MD 187 (OLD GEORGETOWN ROAD) AND ROCK SPRING DRIVE

TRAFFIC SIGNAL PLAN

REVISION "B"

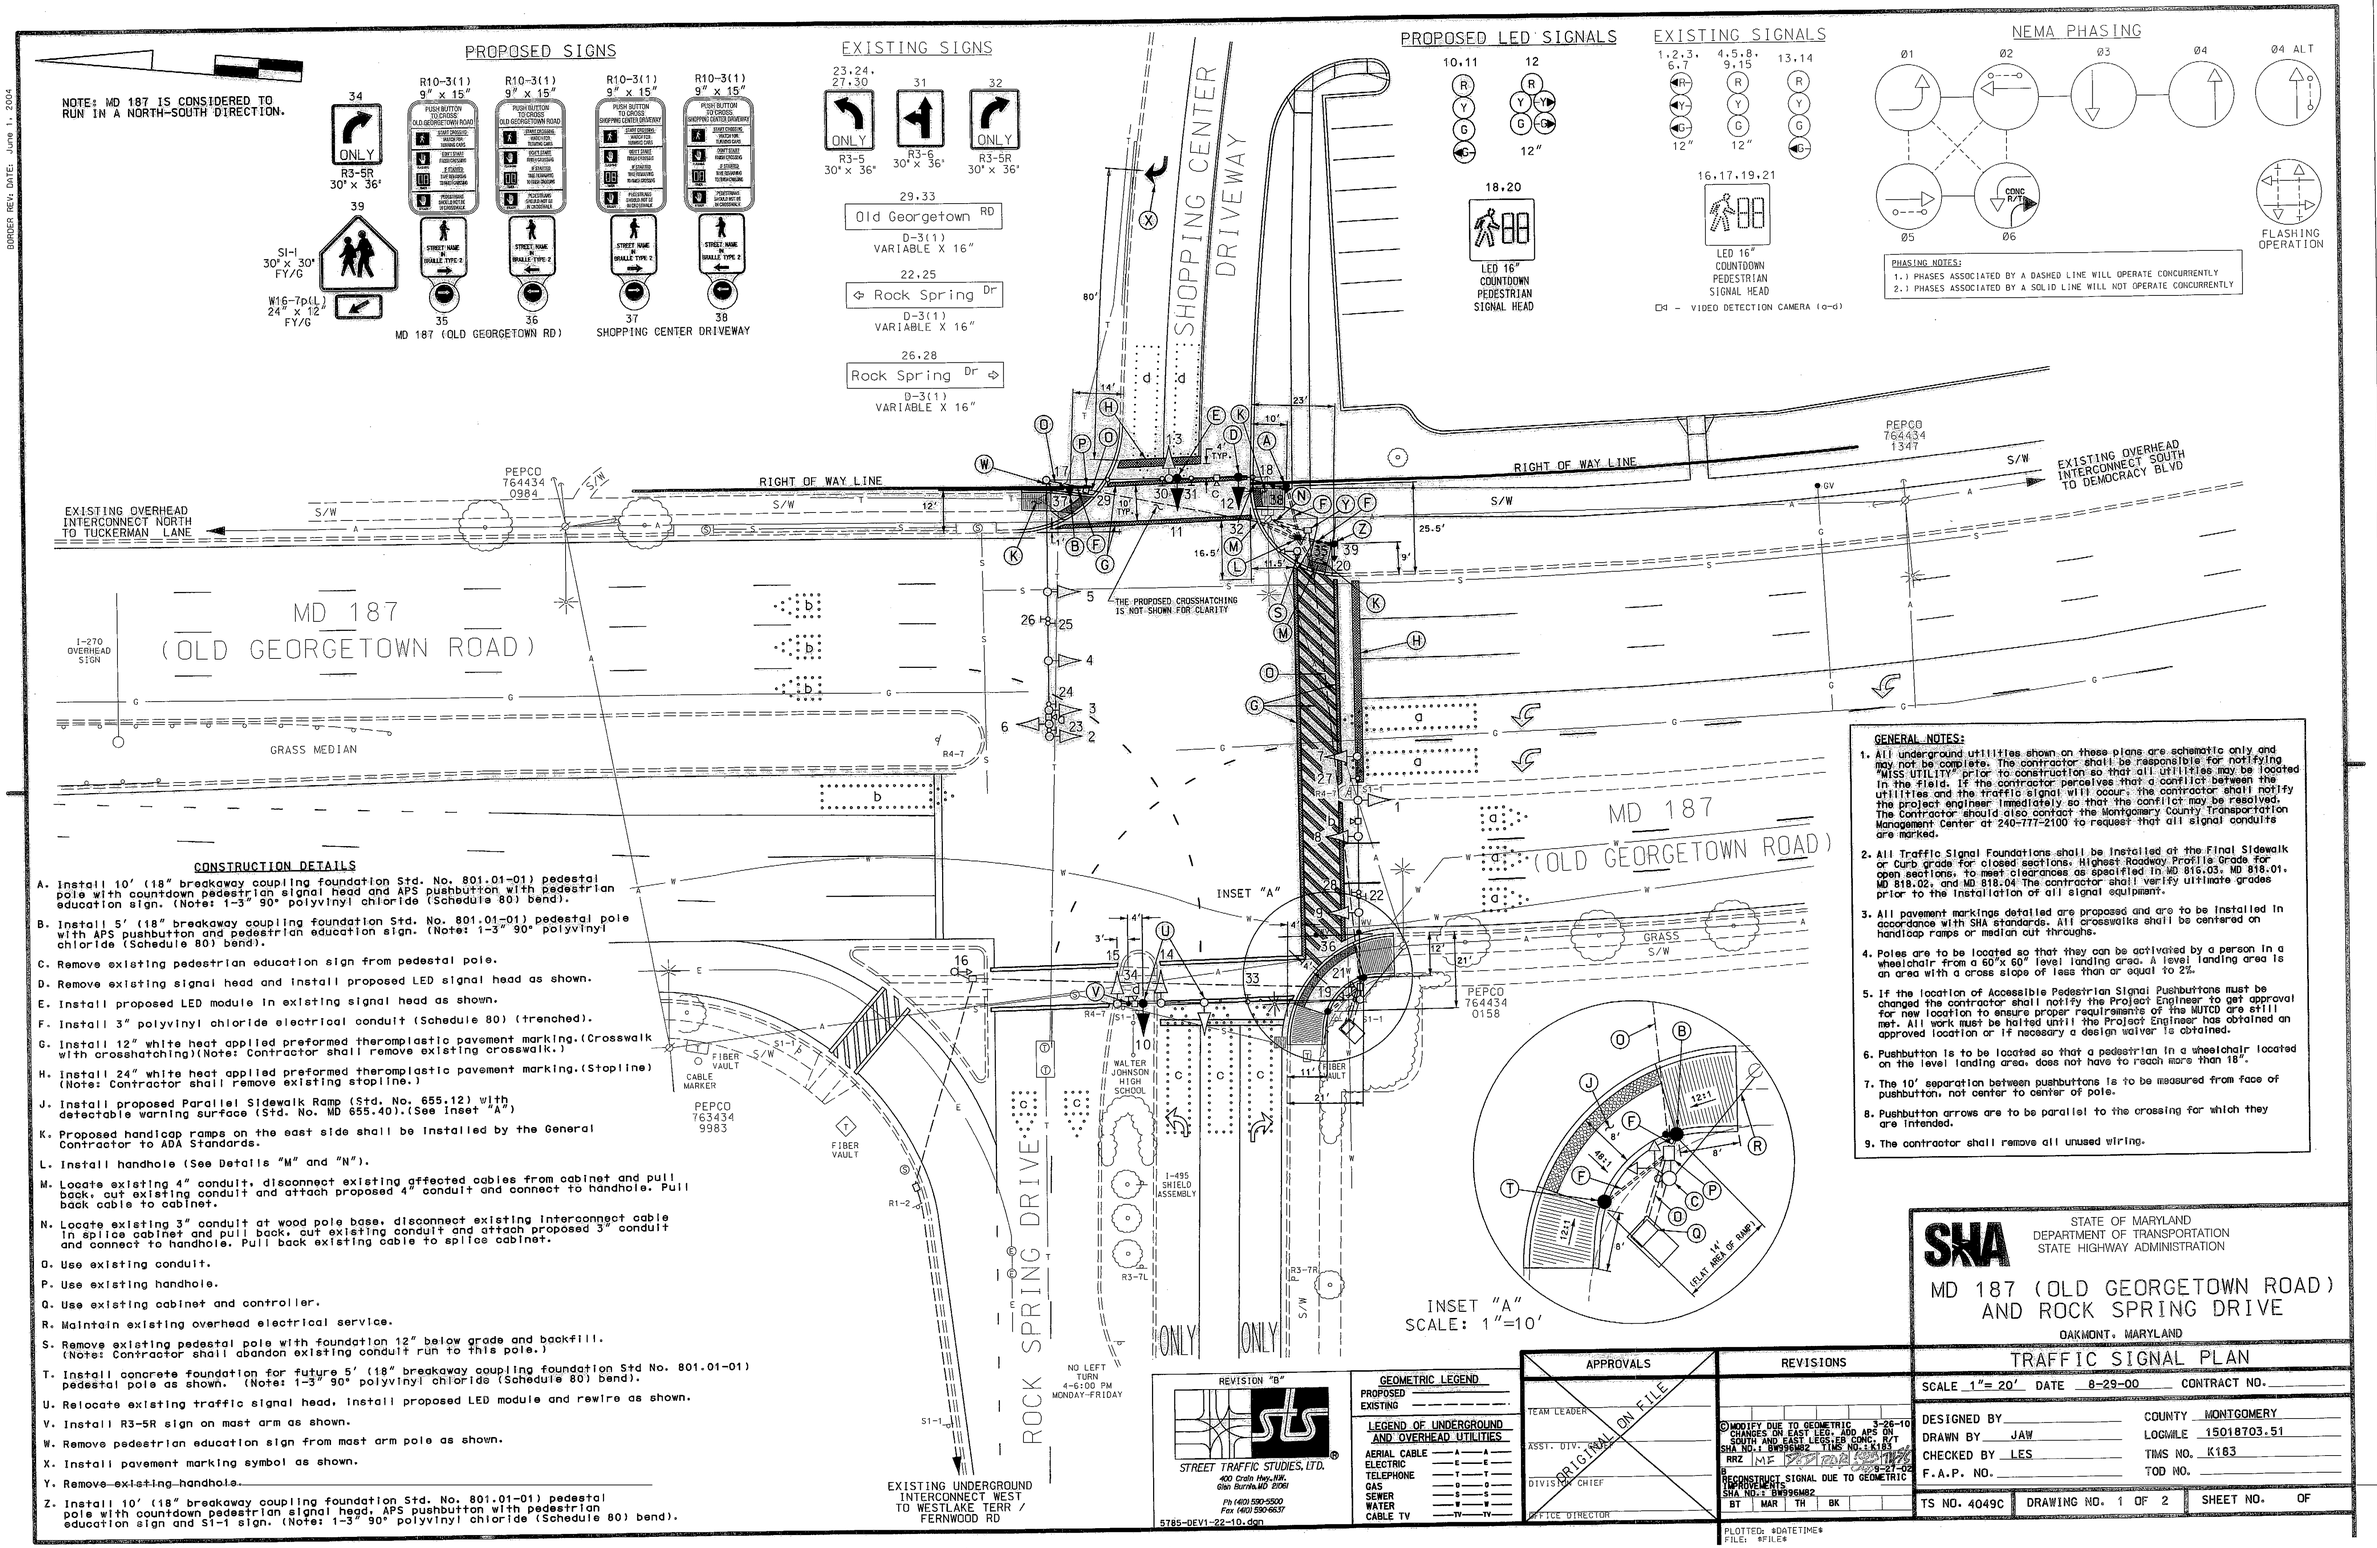
B MODIFY DUE TO GEOMETRIC CHANGES ON EAST LEG. ADD APS ON SOUTH AND EAST LEGS(ED CONC. R/T SHA NO.1 BW996M82 TIMS NO.: K183						3-26-10
RRZ	MF					9-27-02
B RECONSTRUCT SIGNAL DUE TO GEOMETRIC IMPROVEMENTS SHA NO.1 BW996M82						8-29-00
BT	MAR	TH	BK
